CHATHAM COUNTY PURCHASING & CONTRACTING DEPARTMENT

ADDENDUM NO. 1 TO 18-0092-4

**FOR: PAVEMENT REHABILITATION - 2018 FIRST LET**

TYPICAL SECTION 1

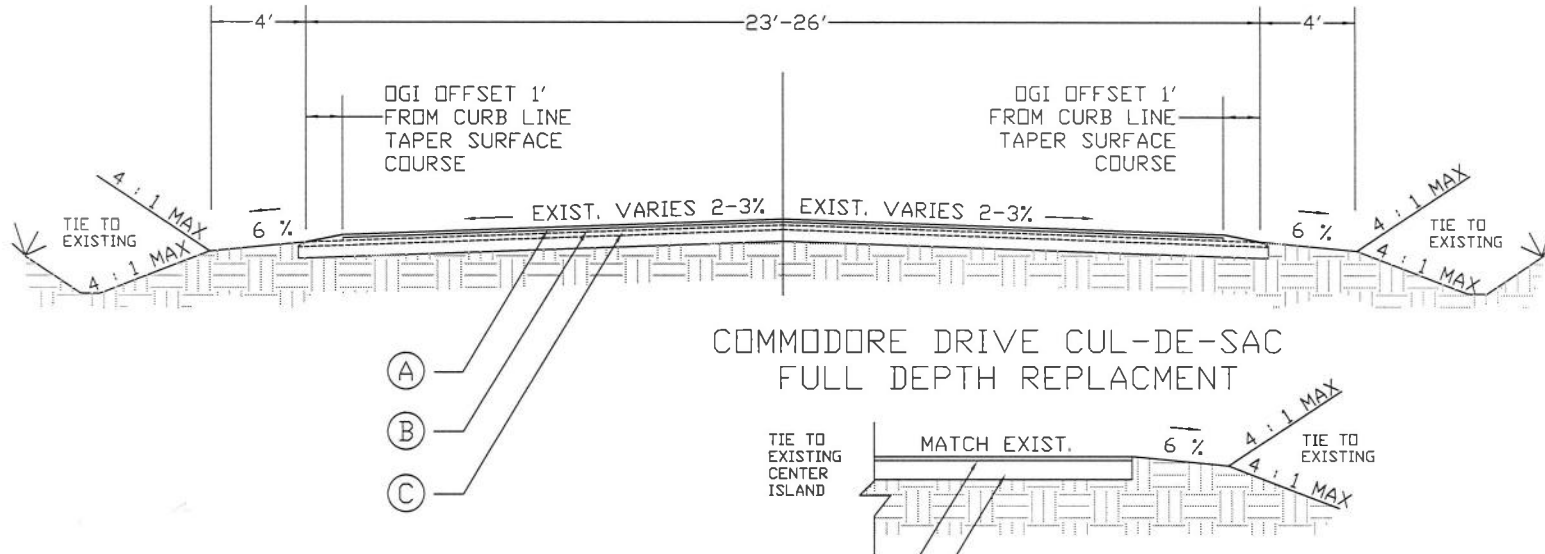
**Road name added to Typical Section 1 and Shoulder grading requirements added to Typical Section 2**

AUTUMN LEAVES COURT, MAPMAKER COVE, REDAN DRIVE, RIGGER COURT, STONEBRIDGE DRIVE, SUMMER WINDS DRIVE AND SURREY ROAD
